Section III (Remarks)

Amendment of the Specification

Submission of Replacement Sheets of Drawings

FIG. 12

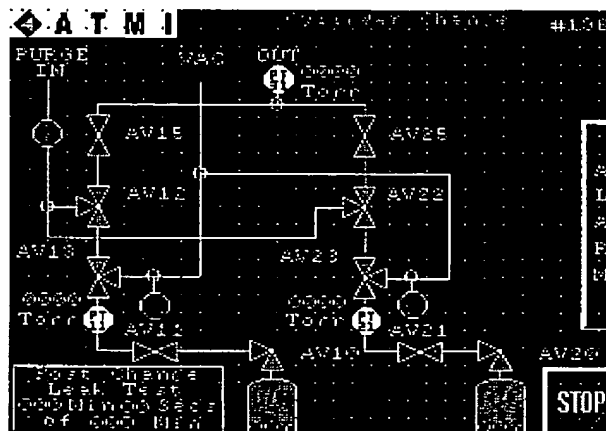
In the December 10, 2004 Office Action, the Examiner objected to the originally filed drawings of the application as allegedly lacking features specified in the claims. Specifically, the Examiner identified the timer as claimed in claims 8, 12, 13 and 42 and the pumper cabinet as recited in claims 23 and 52 as having to be shown, or such features cancelled from the claims.

The Examiner's attention is also directed to originally filed FIG. 12, which is reproduced below for ease of reference, as showing a timer in the lower left-hand portion of the screen.

The timer indicates elapsed time ("000 Min 00 Secs of 000 Min") of the Post Change Leak Test.

The foregoing clearly provides sufficient basis in the drawings for the recital of a timer in claims 8, 12, 13 and 42.

FIG. 14

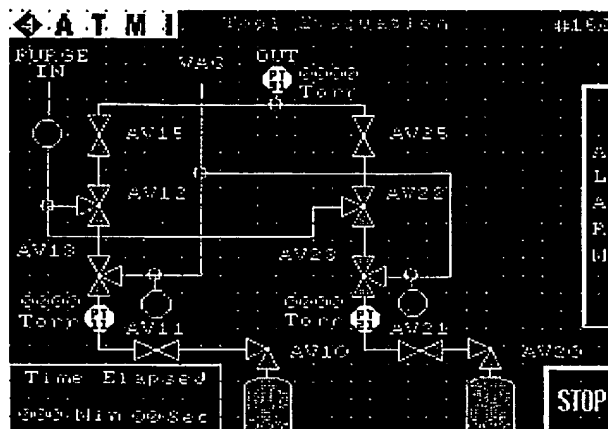
See also originally filed FIG. 14, which likewise shows the timer in the lower left-hand portion of the screen.

The timer shows "Time Elapsed" as "000 Min 00 Sec." Similar screens containing timers are shown in FIGS. 15 and 17.

FIG. 20

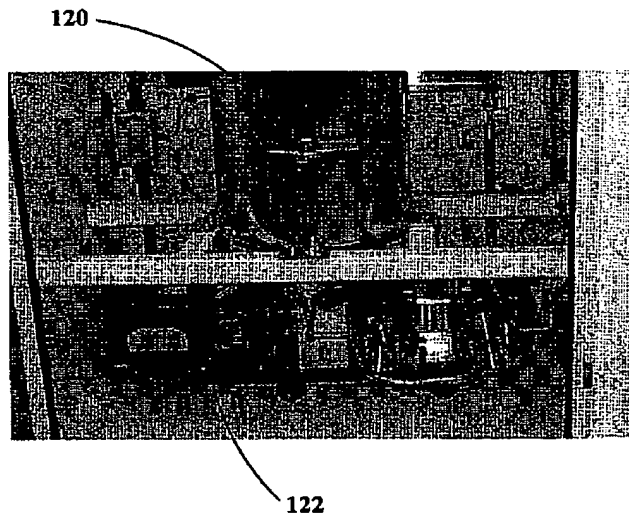
Concerning the pumper cabinet, such cabinet is clearly shown in FIGS. 19 and 20 of the application, and described in paragraphs [0087] – [0091]. In paragraph [0087], the application states that "[T]he Pump component can also be a constituent of an extractor module 100 as shown in FIG. 19, which may comprise a pump and a surge tank (not shown in FIG. 19; see FIG. 20, described more fully hereinafter). . .[T]he extractor system components may be housed in an exhausted and monitored enclosure, with the gas delivery hardware being housed in a main cabinet 102 equipped with viewing window 108..." (emphasis added).

The extractor module as shown in FIGS. 19 and 20 thus includes pumper cabinet 102. Originally filed FIG. 20 of the application, reproduced below for ease of description, clearly shows the

extractor pump 122 in the cabinet 102 lower portion.

Consistent with the foregoing, so that all formalistic issues are resolved, the specification has been amended in paragraph [0090] so that the first sentence of such paragraph expressly uses the term “pumper” as used in the originally filed claims 23 and 52:

“[0090] The main cabinet 102 thus constitutes a pumper cabinet that encloses a surge tank 120 and an extractor pump 122, as shown in FIG. 20, process plumbing and the purge and vent plumbing and is monitored for exhaust pressure.”
